From: "Sarah Jones" <sjones@milfordplanning.com.au>
Sent: Thu, 24 Apr 2025 17:30:02 +1000
To: "Development Assessment" <developmentassessment@townsville.qld.gov.au>
Cc: "Taryn Pace" <taryn.pace@townsville.qld.gov.au>
Subject: M2258 - MCU24/0092 - Response to Council's Information Request and SARA's Further Advice Notice
Attachments: OM2258 - Final Information Request Response.pdf

Re: Information Request Response
Development Application seeking a Development Permit for Material Change of Use – Health Care Services (Medical Centre Extension) and Shop (Pharmacy) on land described as Lots 56 and 57 on RP703491 and located at 110-112 Bowen Road, Rosslea

Information Request

Application no:	MCU24/0092
Assessment no:	1806044
Proposal:	Health Care Services (Medical Centre Extension) and Shop (Pharmacy)
Street address:	110 Bowen Road ROSSLEA QLD 4812 112 Bowen Road ROSSLEA QLD 4812
Real property description:	Lot 57 RP 703491 Lot 56 RP 703491
Applicant's reference:	M2258

1 proposed site plan
sk_02 1 : 150

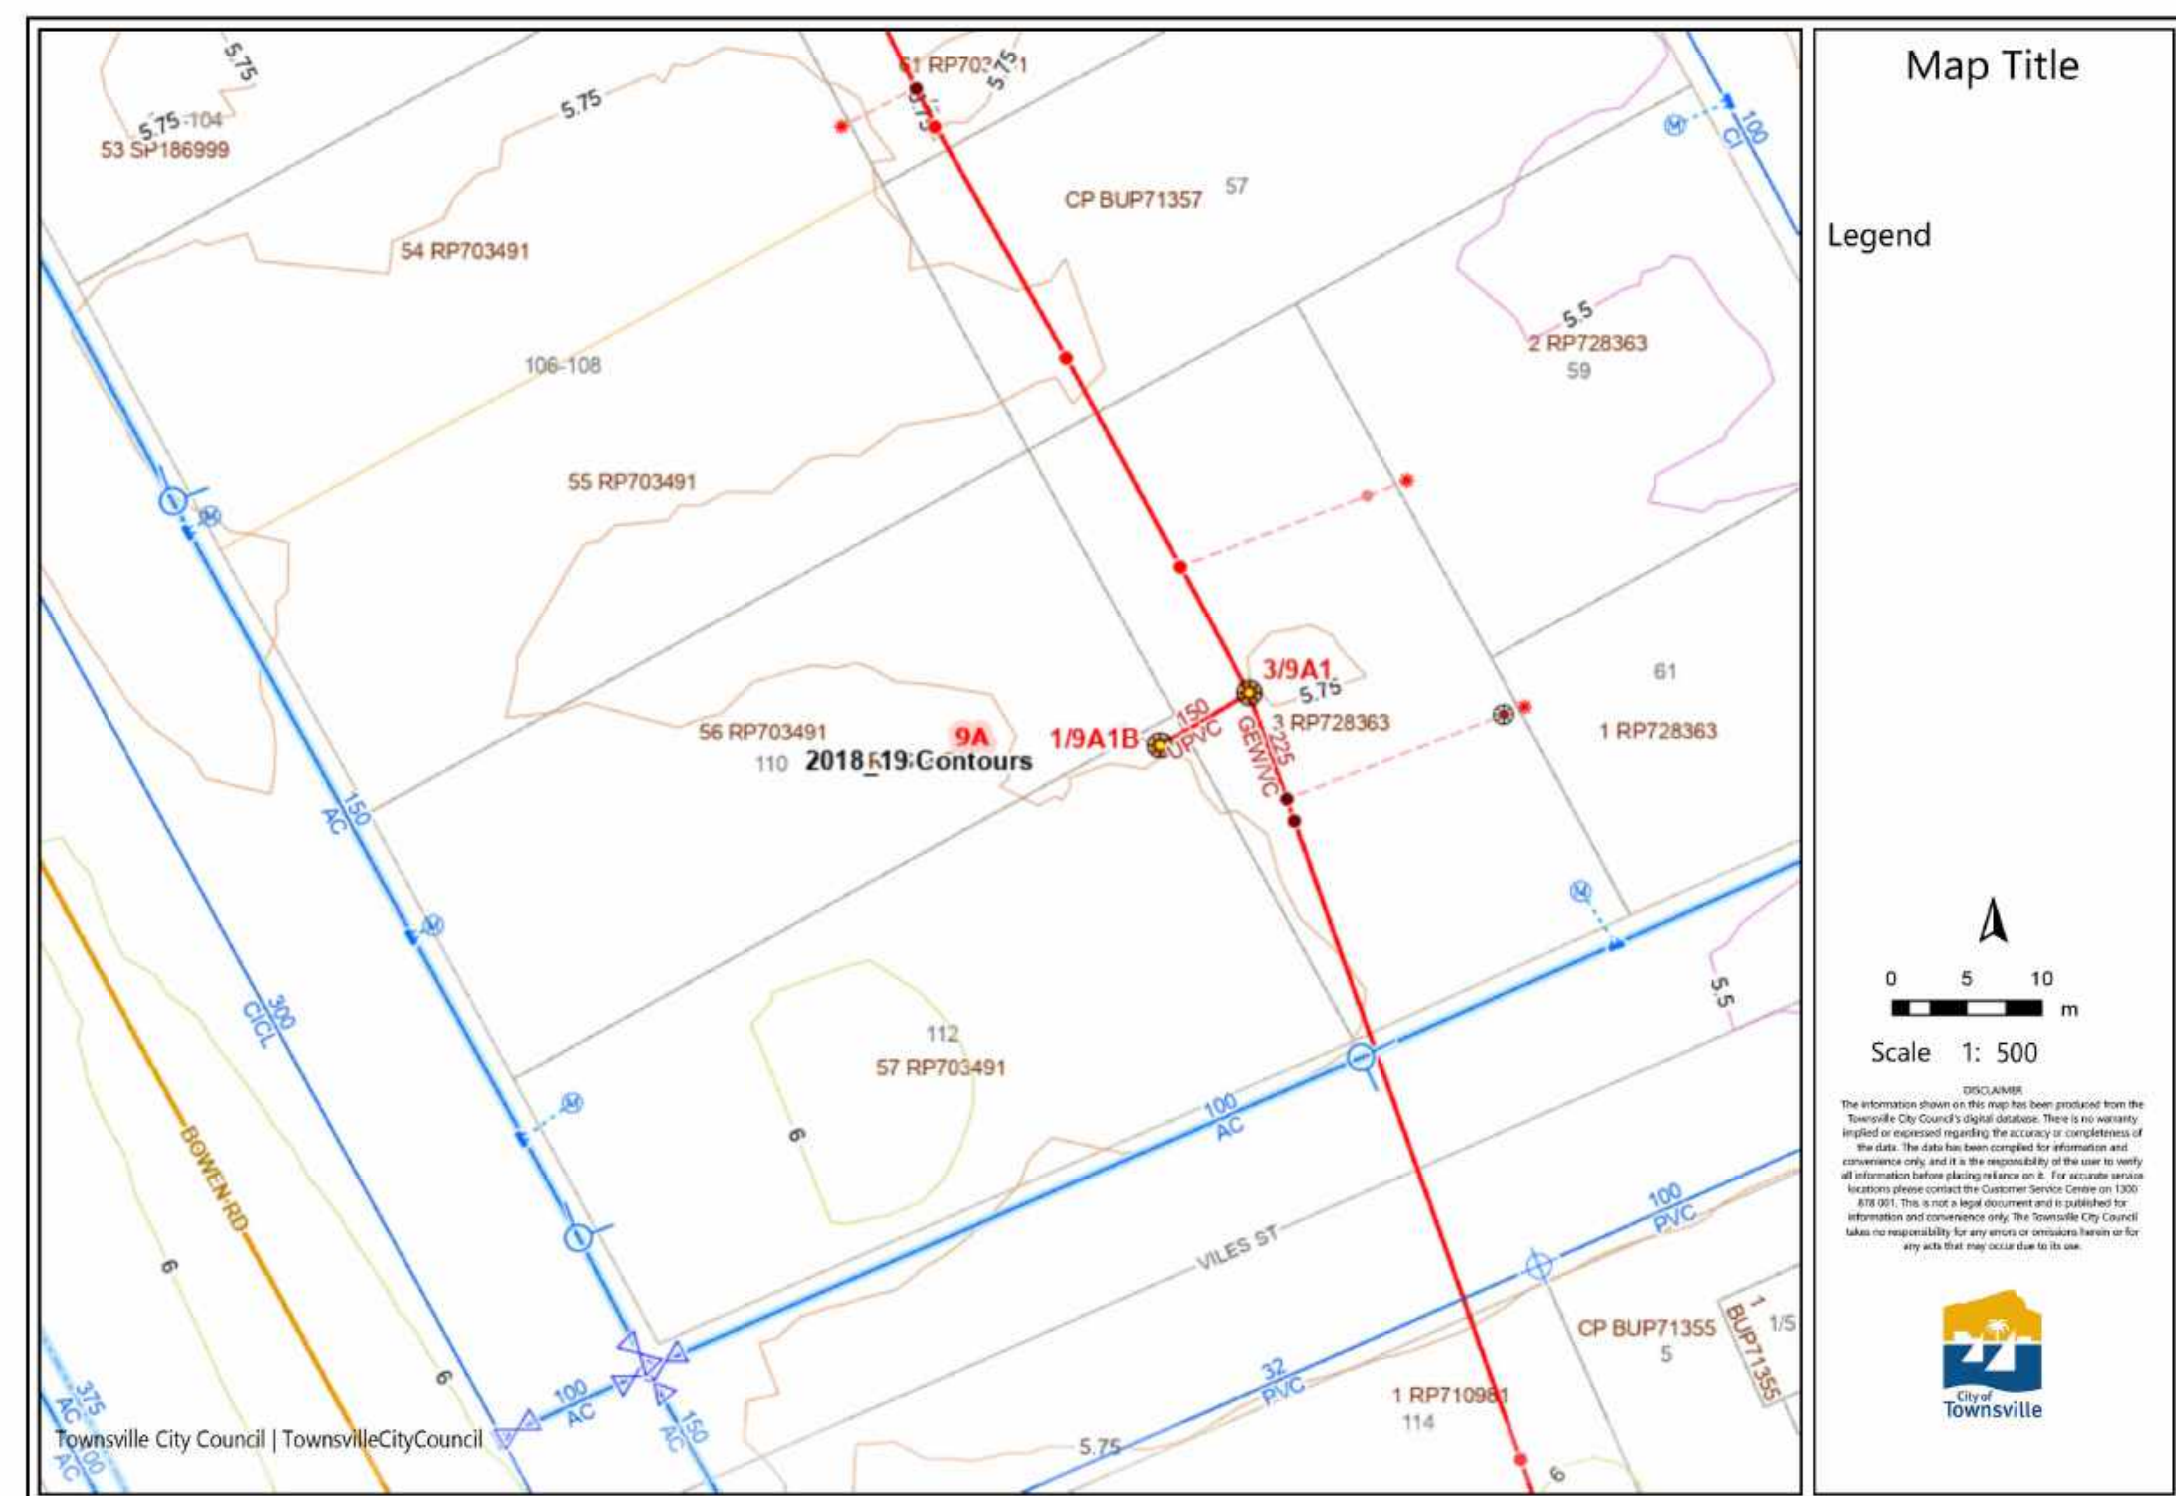
Item 2 Carparking and Access	This item requested the Applicant to provide an amended car parking and access plan to include the following changes: ▪ the consolidation of driveways on Viles Street; ▪ removal of tandem staff carparking at the front of the site; ▪ provision of a dedicated covered car space for the existing caretaker's accommodation, noting the carparking space shown appears to no longer be accessible to vehicles; ▪ provision of a dedicated ambulance bay; ▪ removal of the 4 tandem staff parks located on the north-eastern side of the proposed extension, noting these parking spaces would be required to reverse into oncoming traffic utilising the Bowen Road access without proper visibility, and are therefore unable to function safely; ▪ turning path diagrams for both cars and service vehicles, illustrating how vehicles will manoeuvre into and out of the staff and public parking spaces; ▪ confirmation that the proposed vehicle access from Bowen Road is free from services and other fixtures, noting that the proposed Site Plan (Plan 23-019) currently shows a pad/box within the driveway; and

Item	Suggested Response
	▪ detail of the connections between the internal pathway network and the existing Active Transportation Network. In response to this item, Langtree Consulting Engineers reviewed the proposed car parking layout and access arrangements for the proposed development, as a consequence both have been amended, refer to Attachment 3. Also, refer to Attachment 4 and the amended Traffic Impact Assessment (TIA). It is clear from the amended plans, the following changes have been made: ▪ consolidation of driveways on Viles Street; ▪ removal of tandem staff carparking at the front of the site; ▪ the design of the doors on the bin storage area have been amended to avoid conflict with the caretakers accommodation's parking space; ▪ provision of a dedicated ambulance bay; ▪ removal of the 4 tandem staff parks located on the north-eastern side of the proposed extension; ▪ turning path diagrams for both cars and service vehicles, illustrating how vehicles will manoeuvre into and out of the staff and public parking spaces; ▪ the existing Telstra pit will be relocated, with the appropriate authorisation sought from Telstra; and ▪ detail of the connections between the internal pathway network and the existing Active Transportation Network. The changes to the car parking layout and removal of the tandem spaces from the north western side of the proposed extension has resulted in the number of parking spaces reducing to 29, one service vehicle/ ambulance space and bicycle spaces. In addition to these car parking spaces, off-street parking is available within the vicinity (i.e. Viles Street and Bowen Road). Further, a percentage of patient will travel to the medical centre by bus, taxi or will get dropped off and picked up from the medical centre by family or friends. The medical centre is also well connected to the existing footpath network along the Bowen Road frontage and is in reasonable walking distance for some patients. It is considered that the above response, amended plans and revised TIA, sufficiently address this item.

- Consolidation of the proposed crossovers/ driveways to Viles Street to provide a single vehicle crossover/driveway;
- Removal of the tandem staff carparking spaces located along the Bowen Road frontage of the site;

- Confirmation that the proposed vehicle access from Bowen Road is free from services and other fixtures, noting that the proposed Site Plan (Plan 23-019) currently shows a pad/box within the driveway; and

The applicant is requested to provide an amended site plan illustrating a densely planted landscape buffer with a minimum width of 2m along all boundaries shared with a residential zone. Amended plans should also indicate the type of boundary screen fencing to be provided (including the proposed 'wall' between the subject site and adjoining property at 106-108 Bowen Road, Rosslea) and the provision of appropriate street trees to both road frontages.

Revision Schedule		
No	Description	Date
1	revised parking layout	25.02.11
